3.2 Kybong

3.2.4 Matilda Issue 2 – Better Alignment

**Bruce Highway (Cooroy to Curra)
Strategic Planning Study
Recommended Corridor Report**

Figure 3.2a
Kybong Interchange -
Matilda Option

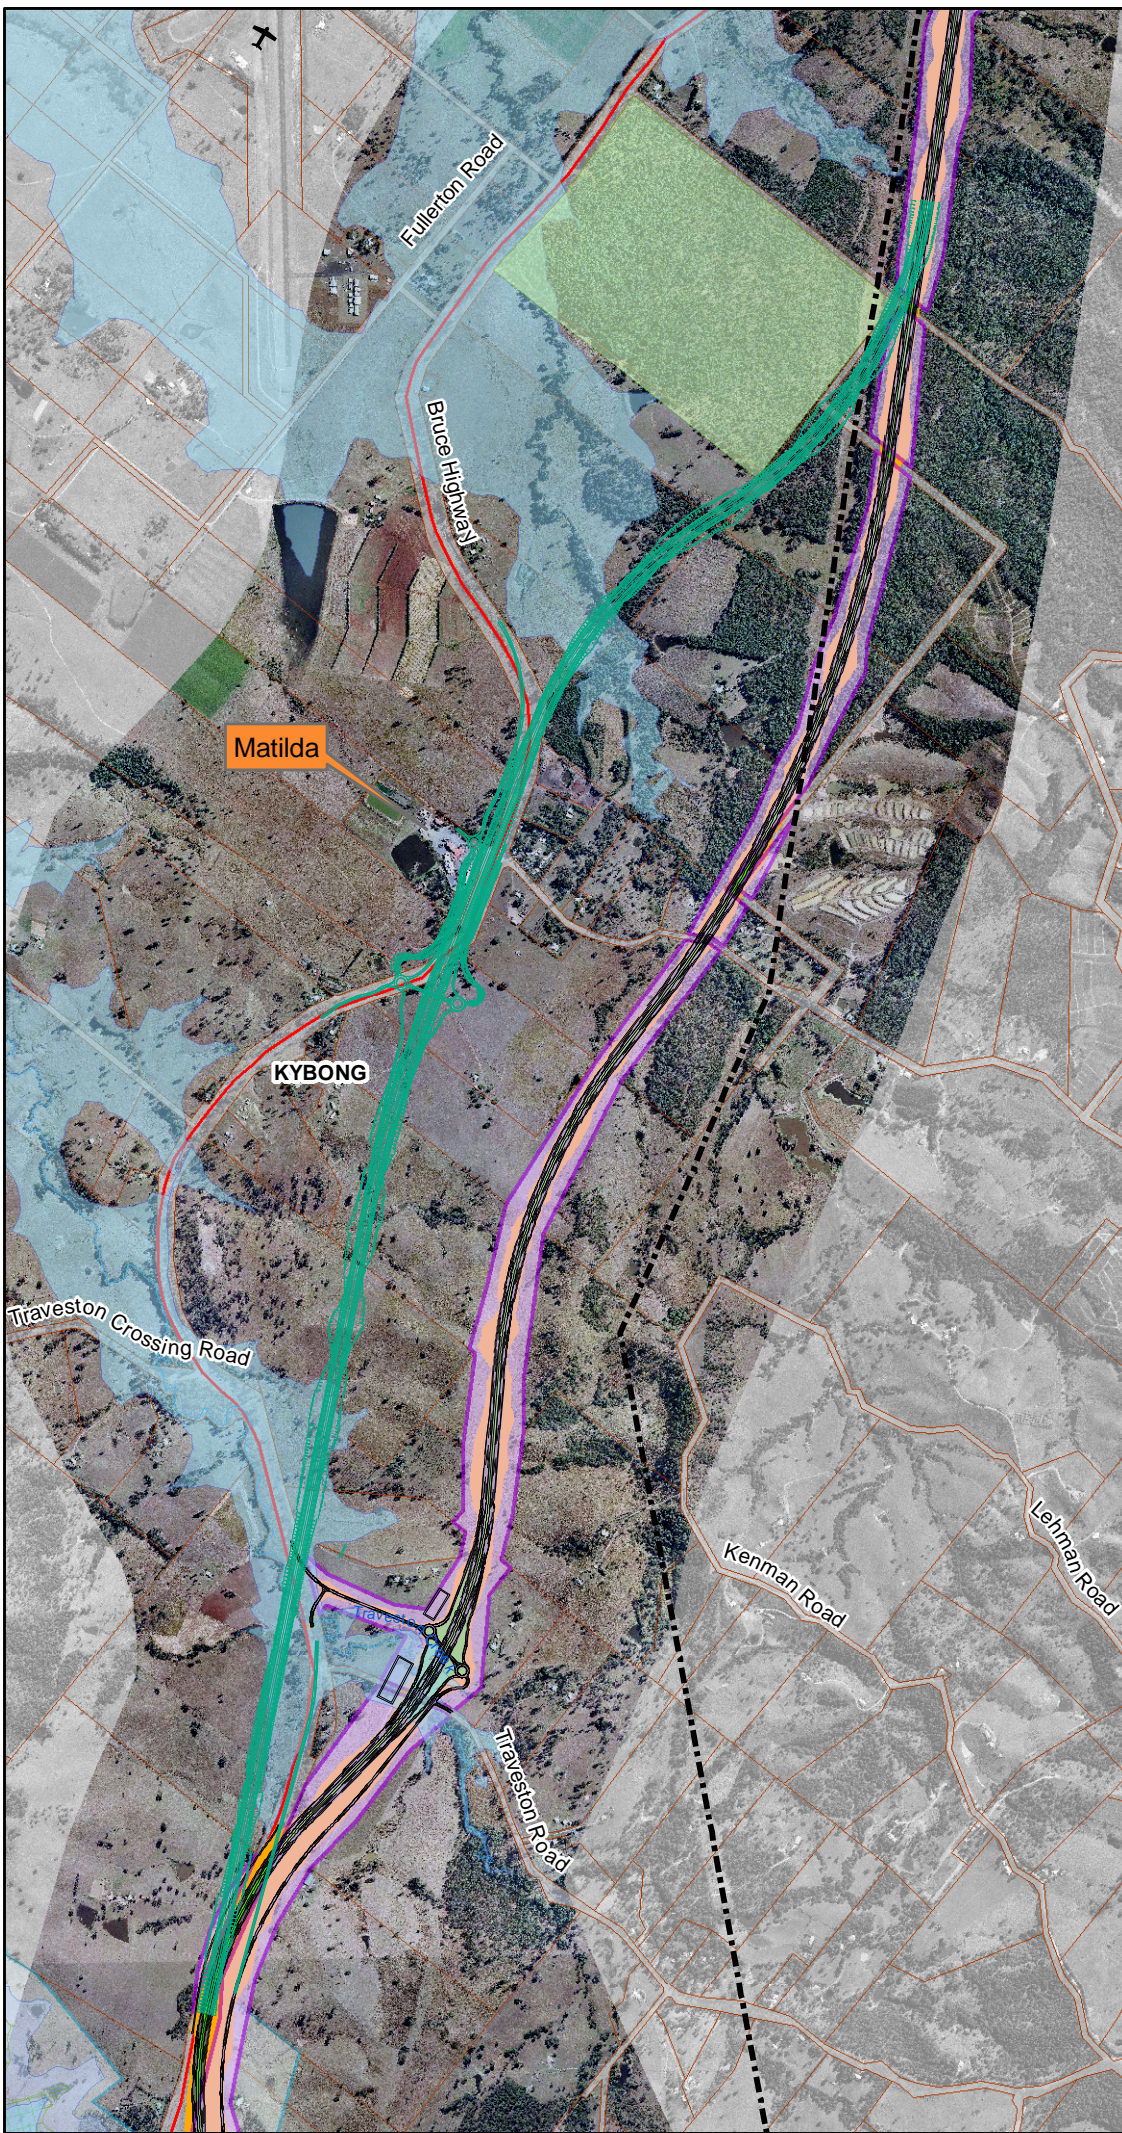
The study team has reviewed Matilda's alternative alignment and modified it to achieve the study's technical highway engineering requirements in terms of sight distances, access arrangements and intersection forms. Figure 3.2a shows the study team's version of the Matilda proposal for a Kybong Interchange.

The alignment of the Matilda proposal and the proposed corridor are similar in regards to standards by way of horizontal and vertical curves and vertical grades. When considering the stageable section for construction (leaving the existing highway at Kybong and reconnecting to the existing highway via the Woondum interchange) both options have similar earthworks, construction costs and environmental impacts. The Matilda proposal is considered further below:

For the new highway corridor to pass in front of the Matilda site, the existing road reserve (generally 60m wide; 75m directly in front of Matilda) must be increased significantly. The road corridor would need to provide interchange entry/exit ramps and service roads on both sides of the corridor in this vicinity. This combined with the earthworks required to achieve the high standard alignment, requires the corridor to be at least 130m wide. Therefore the Matilda proposal generally creates a land requirement 70m wider than the existing highway reserve.

Matilda's proposal aligns the new corridor as far to the east as possible without resumptions on the eastern side (ie within the highway reserve).

This creates a land requirement on the properties fronting the western side of the existing highway, including Matilda's site. Other properties with land implications on the western side include a large ginger seed farm and long narrow rural properties which back onto the Mary River.

The land take on Matilda's site requires the relocation of the fuel bowsers, associated covered structure and parking hardstand areas. The bower relocation and amended access/circulation would require significant reinvestment to develop the site and allow it to function at an acceptable standard as a service centre (ie. circulation of traffic flow between bowsers, payment for fuel, dining facilities and rest stop amenities).

The new corridor has limited access, with movements onto and off the new corridor at widely spaced interchanges. The Matilda alignment uses the existing highway reserve; therefore the existing highway needs to be reinstated to continue to perform the functions of a local service road. Additional costs in the order of \$10M (in today's dollars) are associated with this road relocation and related works.

One of the differentiators between the Matilda proposal and the proposed corridor is the location of the interchange. Interchange locations are primarily determined by the road network requirements for accessibility and route interconnectivity. However, there are limits to the number of interchanges that can be accommodated and the spacing of ramp terminals without compromising the capacity and safety of the road.

With the Matilda proposal, access to the site is less than ideal due to the interchange location. It requires northbound motorists to exit the highway and travel approximate 800m on the exit ramp, negotiate a roundabout, travel a further 400m on the service road to enter the site. To rejoin the highway motorists must backtrack approx 400m to reach the interchange. The reciprocal movements are required for southbound motorists.

Based on the evaluation criteria agreed through previous stages of the study, the Matilda proposal has greater social impact on properties than the proposed corridor. The Matilda proposal also affects properties that were not previously impacted by the proposed corridor. Additionally, the proposed corridor has significant community support with the study team receiving a petition from the local Kybong/Tandur Road community which included 64 signatures.

Given the need to provide rest stops along the highway, Main Roads intends to review the current service centre strategy and policy once the highway corridor is finalised. It is recommended that the proposed corridor and interchange between Coles Creek Road and the Woodum Interchange be retained. During detailed planning for the Traveston Crossing

Dam the location and arrangement for the interchange is to be reviewed and opportunities investigated to achieve the best overall community benefit.
